PPP-P-704E  
AMENDMENT-2  
February 20, 1987  
SUPERSEDING  
AMENDMENT-1  
December 28, 1983

FEDERAL SPECIFICATION

PAIS, METAL: (SHIPPING, STEEL, 1 THROUGH 12 GALLONS)

This amendment, which forms part of Federal Specification PPP-P-704E, dated October 30, 1981, is approved by the Assistant Administrator, Office of Federal Supply and Services, General Services Administration for the use of all Federal agencies.

FIG 9 A PRESS-IN TYPE PLASTIC NOZZLE AND CAP CLOSURE  
WITH PLASTIC PUSH-FILL SPOUT

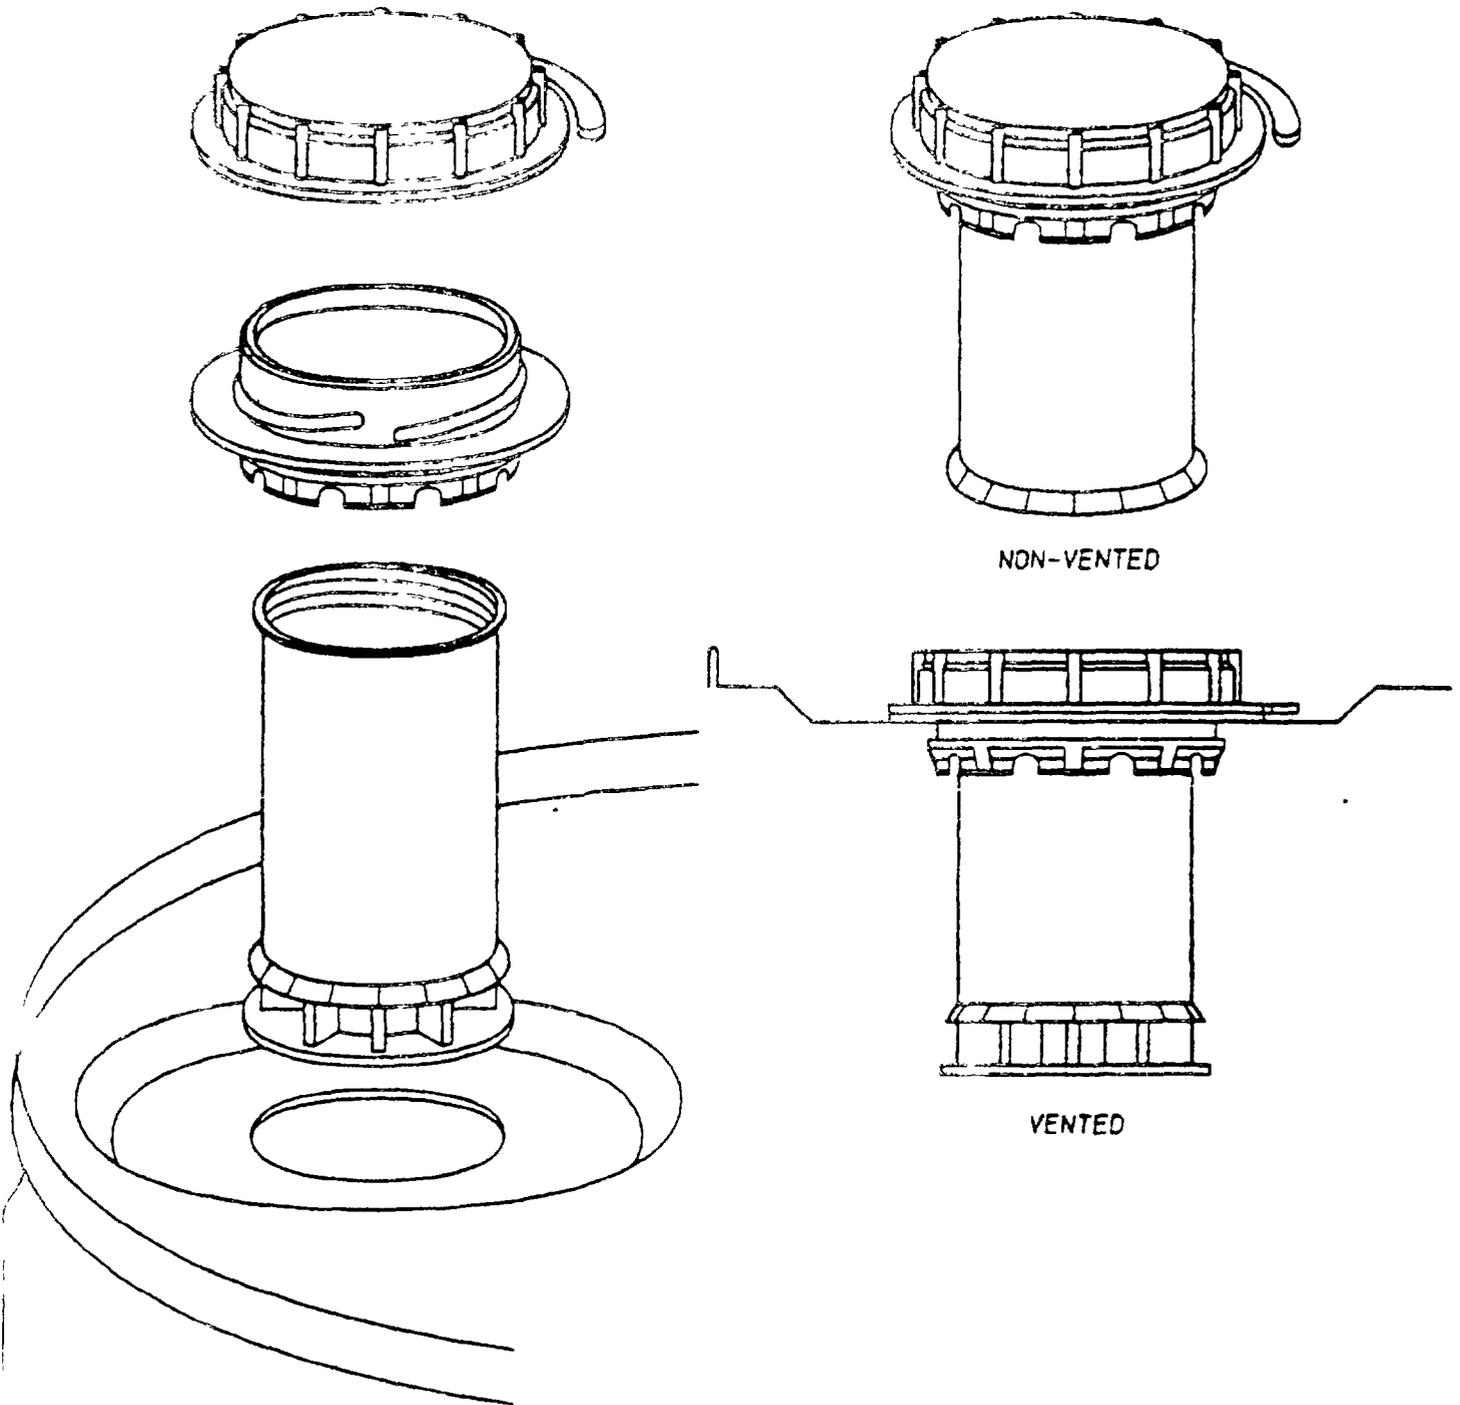
"3.1.4.1.1 Press-in pull-up closure with screw cap with integral tamper evident seal (see figure 9A). The press-in pull-up closure with screw cap with integral tamper evident seal shall be molded of commercial quality polyethylene or comparable functioning plastic. The closure shall be designed to be pressed into the opening in the pail top. The closure shall have the flanges of its neck and its cap fused together in such a way as to form a leak-proof and tamper evident seal. A pull-tab shall be provided on the cap flange for removal of the tamper evident seal. The closure shall have a pouring opening of not less than 1-1/2 inches in diameter. The closure shall include a pull-up pouring spout, either self-venting or non-venting (see 6.2), and molded of commercial quality polyethylene or comparable functioning plastic. The spout shall be able to be raised to fully extended pouring position after removal of the tamper evident seal by means of the screw-cap which is screwed into the pull-up spout. The spout, in extended pouring position, shall tightly engage within the nozzle opening."

3.1.4.9.1, line 2, after "9,": Add "9A,".

FIGURE 10 - COLLAPSIBLE SPOUT

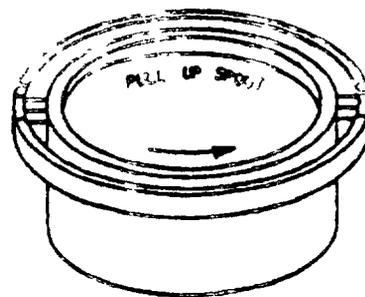
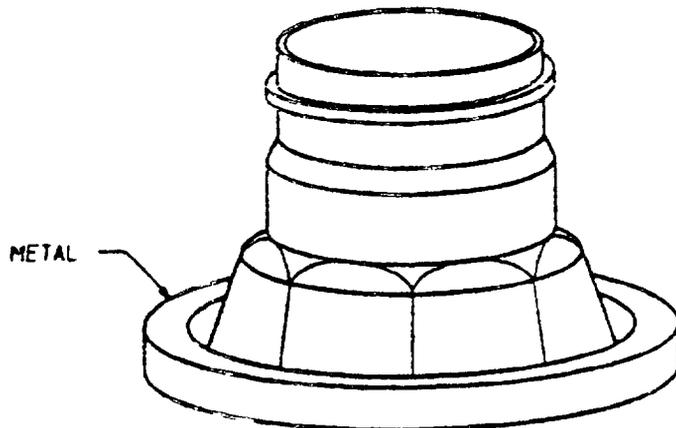
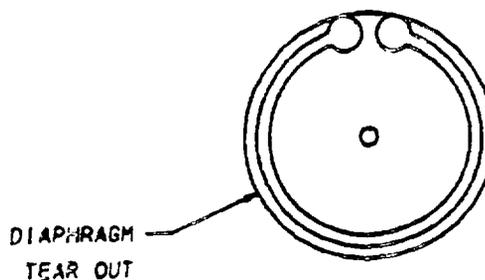
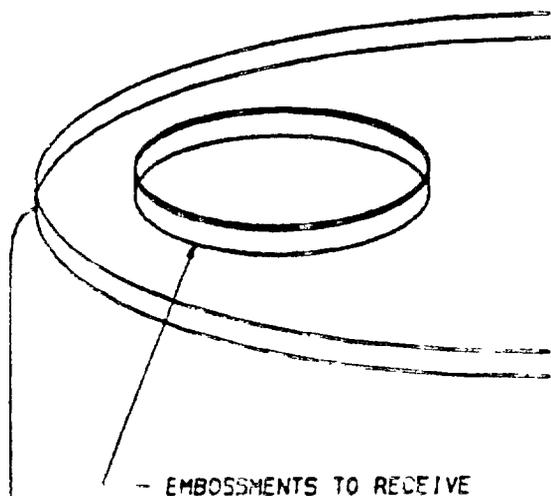
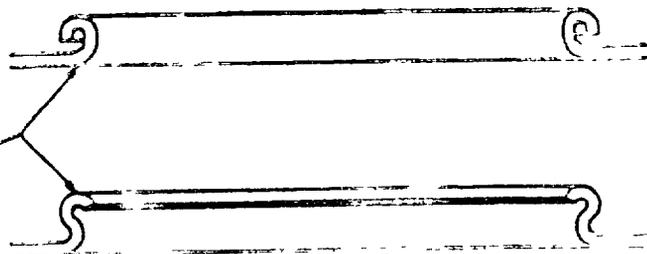
3.1.4.9.4, last line: Delete "(see figure 10)" and substitute "(see figures 10 and 20)".

Figure 10: Delete in entirety, add new figure 10 (attached).

FIGURE 20 - COLLAPSIBLE SPOUTS

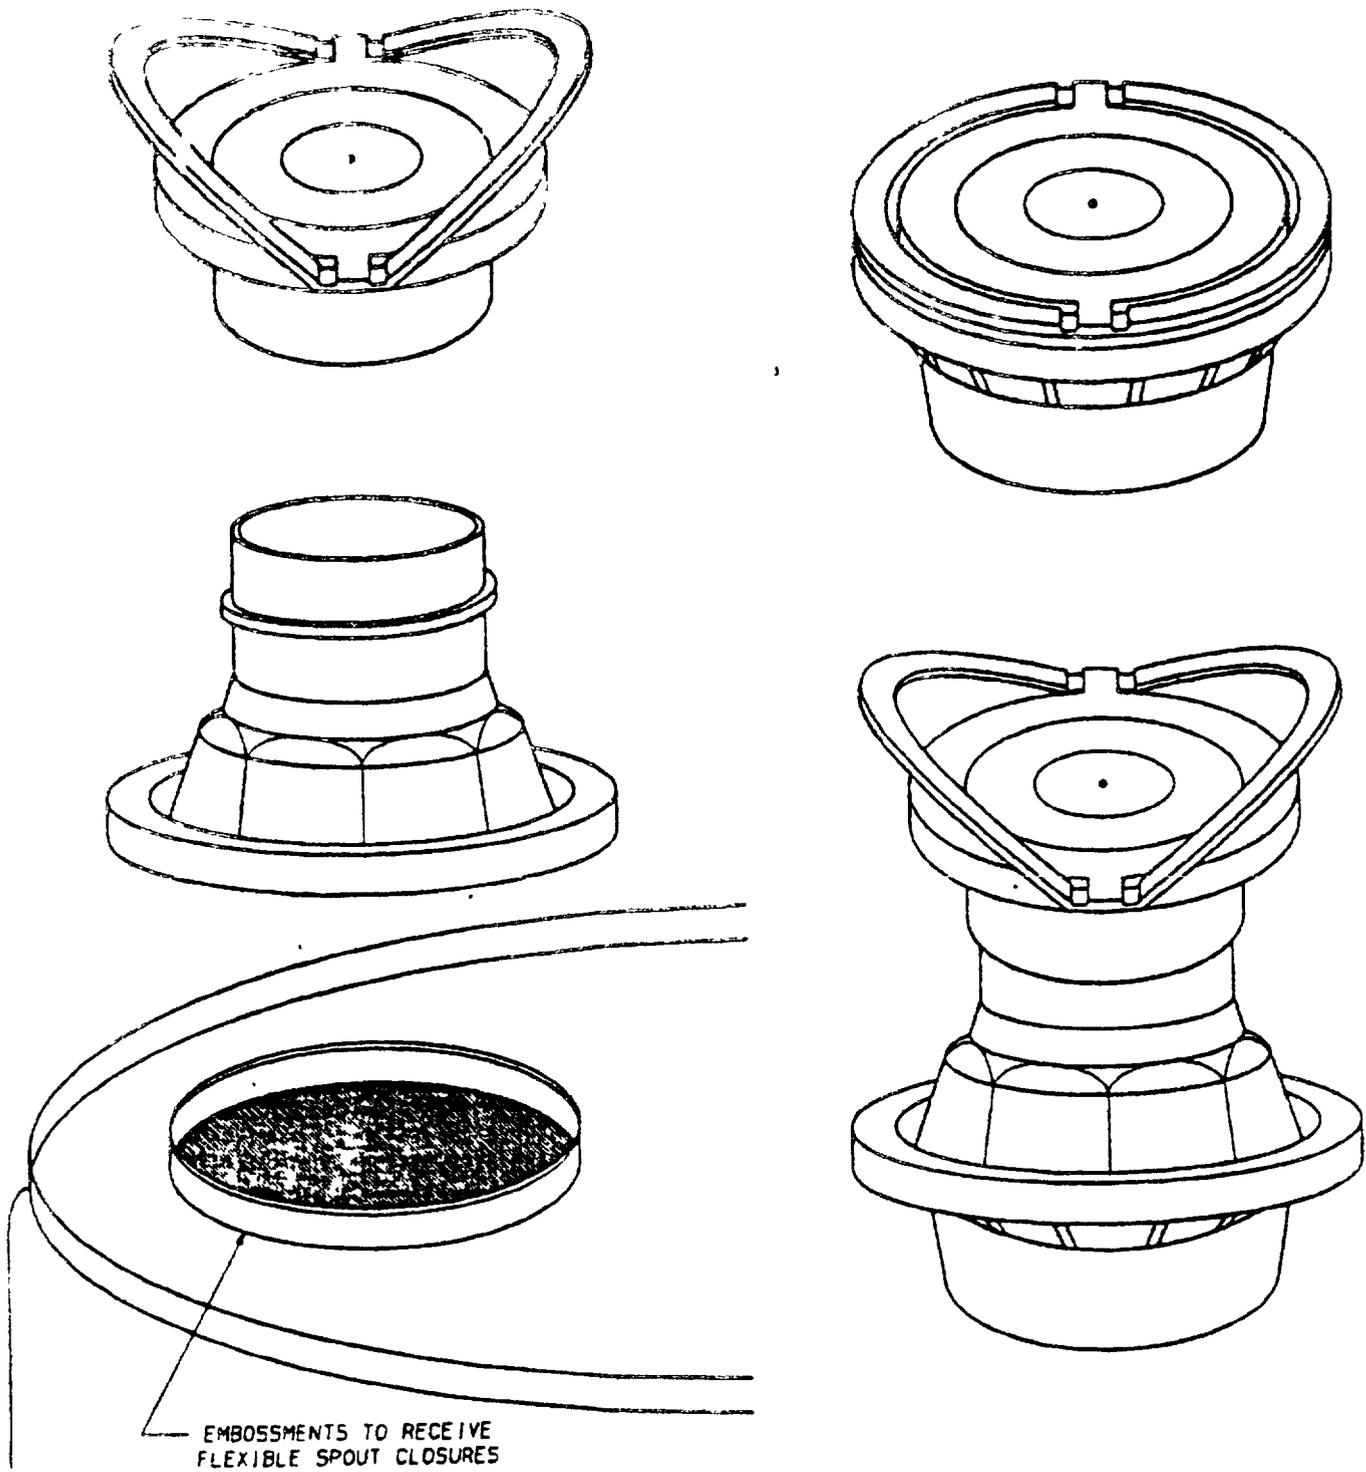
3.1.4.5, line 2: Delete "18" and substitute "20".  
line 20: Delete "flexible" and substitute "collapsible".  
line 20 after "figure 10": add "and 20".  
line 21: Delete ", and 18".

"3.1.4.9.3 Collapsible spout closure. Collapsible spout closure shall be molded of commercial quality polyethylene or a comparable functioning plastic. A tear out diaphragm of the same material shall be molded as an integral part of the pouring spout. The portion of the closure attached to the container shall be molded so as to fit on the outside diameter of the sealing portion of the preformed opening in the container head prior to being clinched. The preformed opening shall provide an opening in the container of approximately 2-3/8 inches to receive the collapsible spout closure. The pour spout shall be collapsed inward and shall be pliable so that it may be extended upward from collapsed position to pouring position. The pouring end of the spout shall have male threads and shall be fitted with a plastic screw cap made of polyethylene or comparable functioning material for reclosing. The plastic screw cap shall have one or two bails or other suitable finger grips for lifting the spout into a pouring position. The bails or finger grips shall be molded as an integral part of the cap (see figures 10 and 20)".
